# SALT FORK EVENT CENTER - FACILITY ZONE GUIDE

Marketing overlay only - room names, chute location and final operating layout require Authority confirmation.

**ALVA ARENA**

## OVERALL FLOOR PLAN

1 OVERALL FLOOR PLAN  
3/64" = 1'-0"

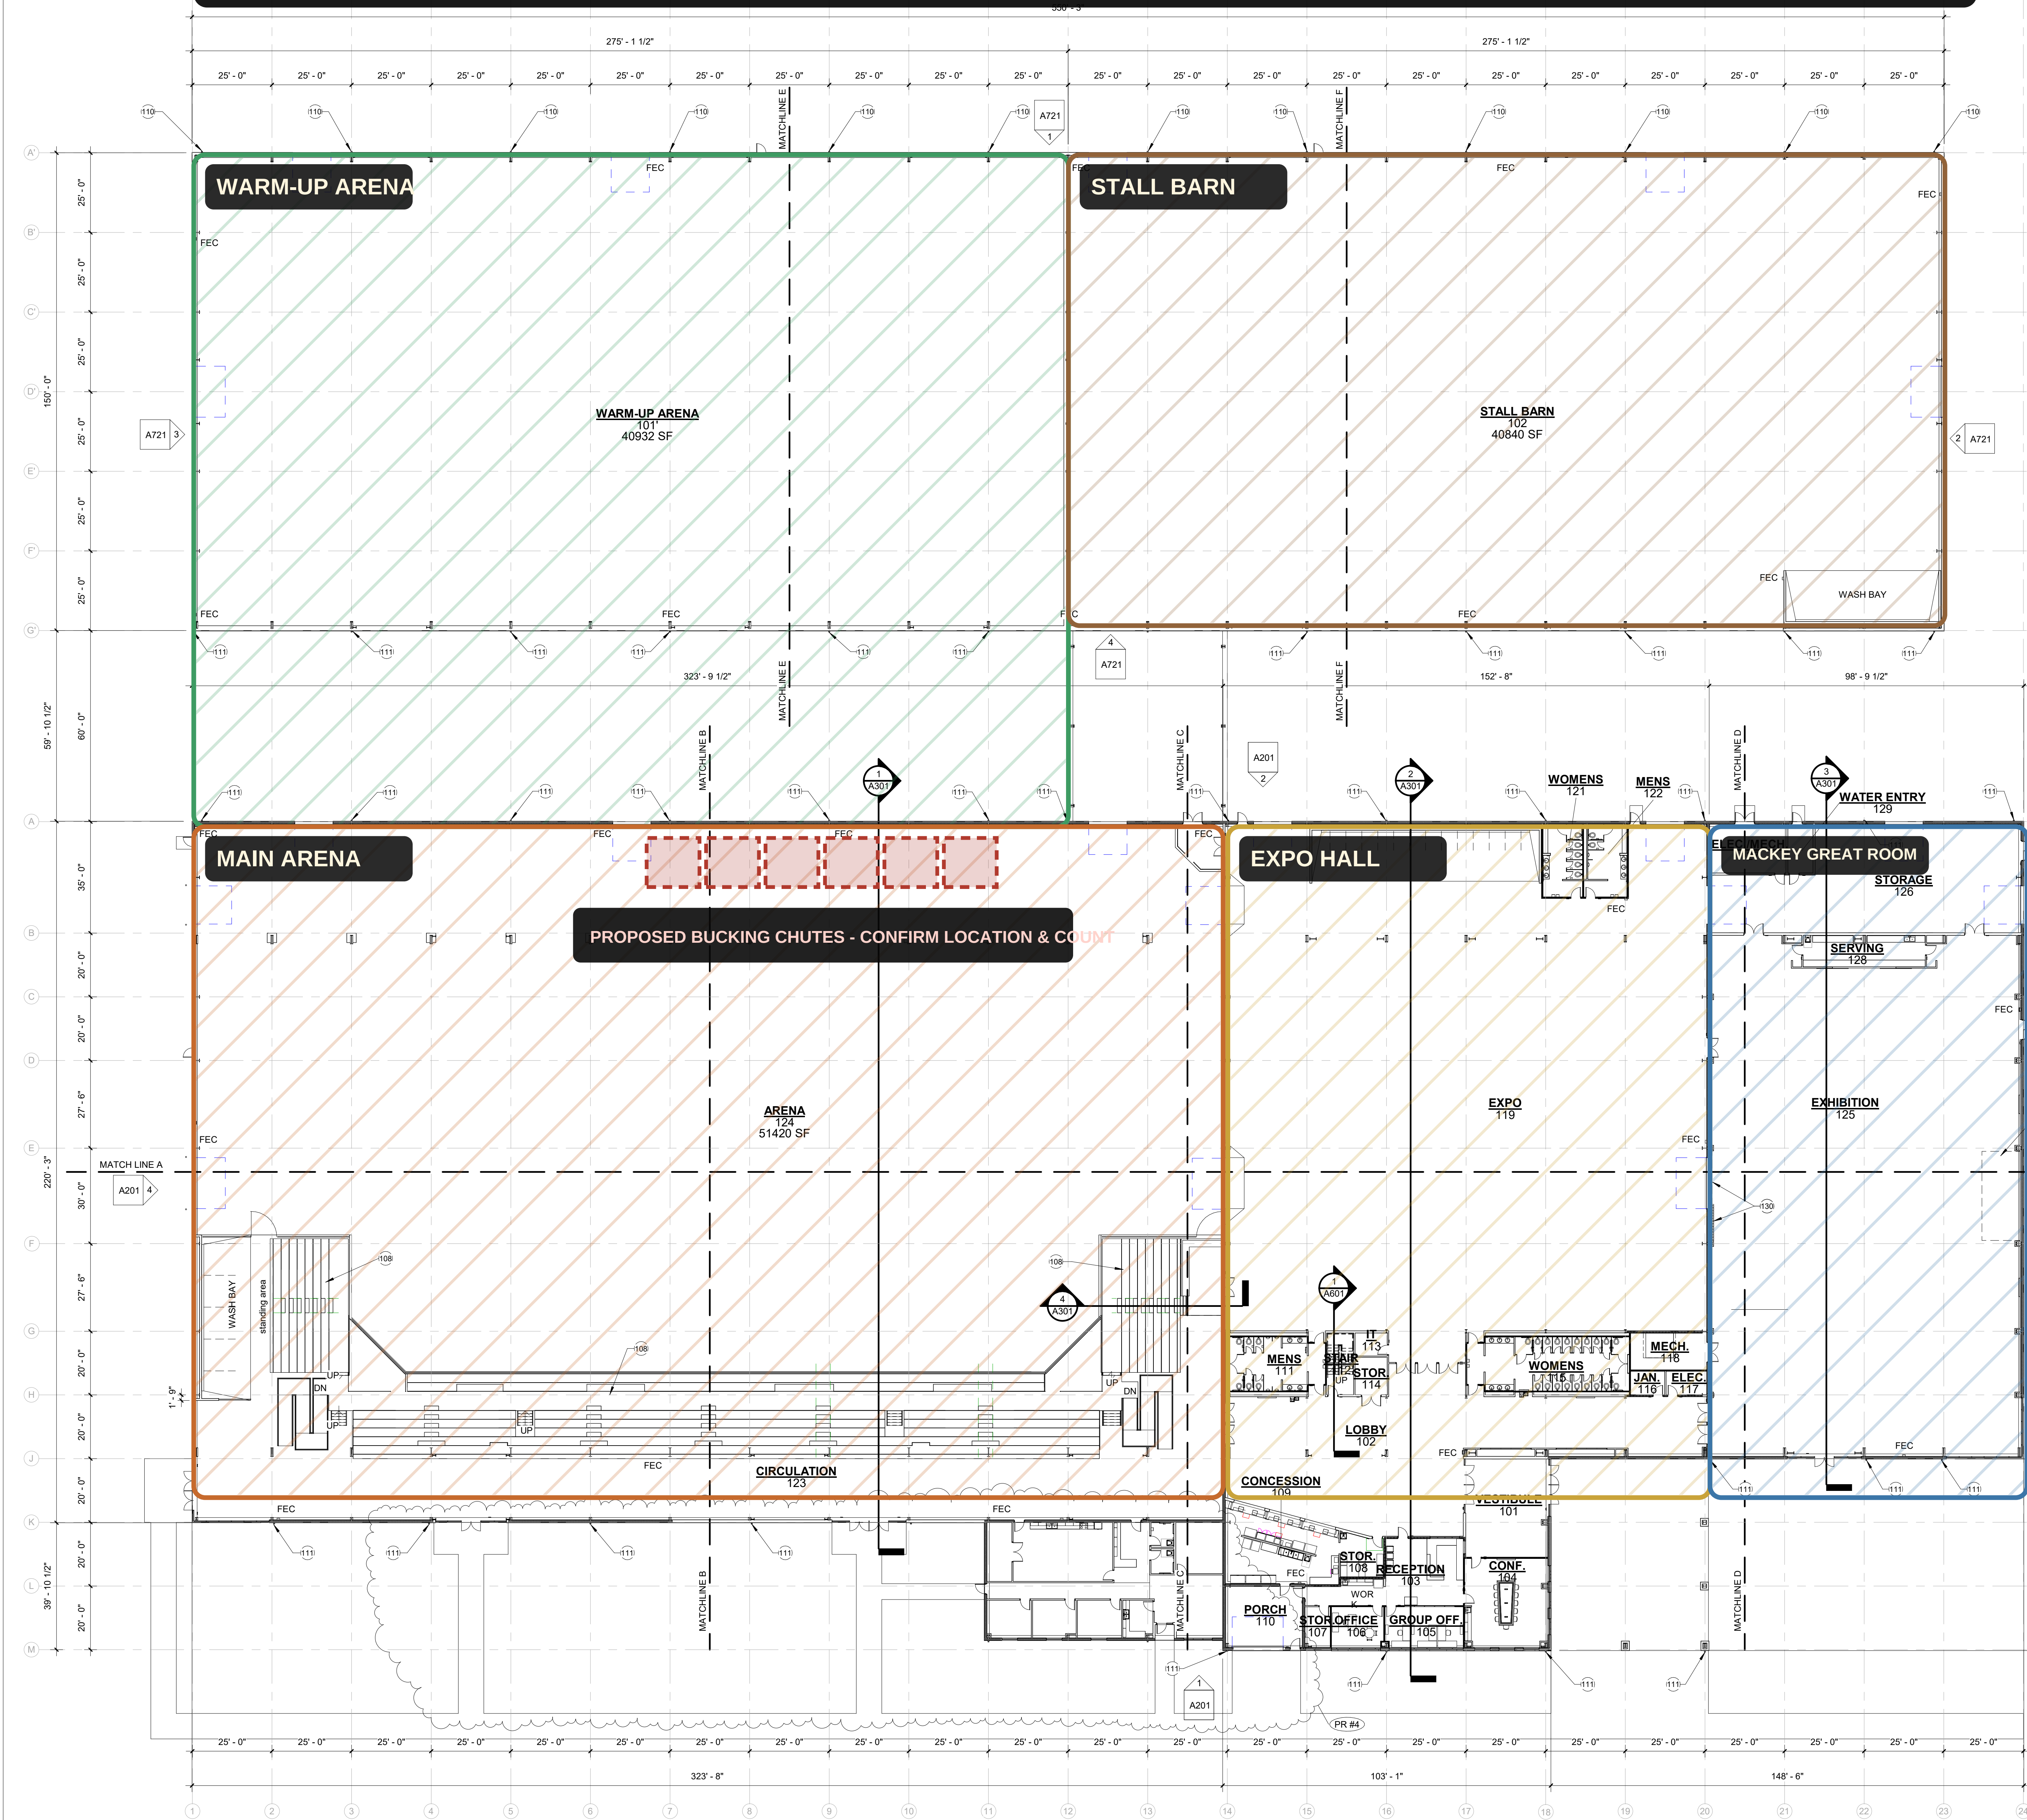
- Confirm Mackey Great Room mapping to the Exhibition area.
- Confirm bucking-chute location, orientation and final count.
- Confirm which zones should be shaded on the public web plan.
- Supply three window-view photos: Mackey Great Room, Expo Hall and Main Arena.
- Reconcile drawing areas with current published square footage.
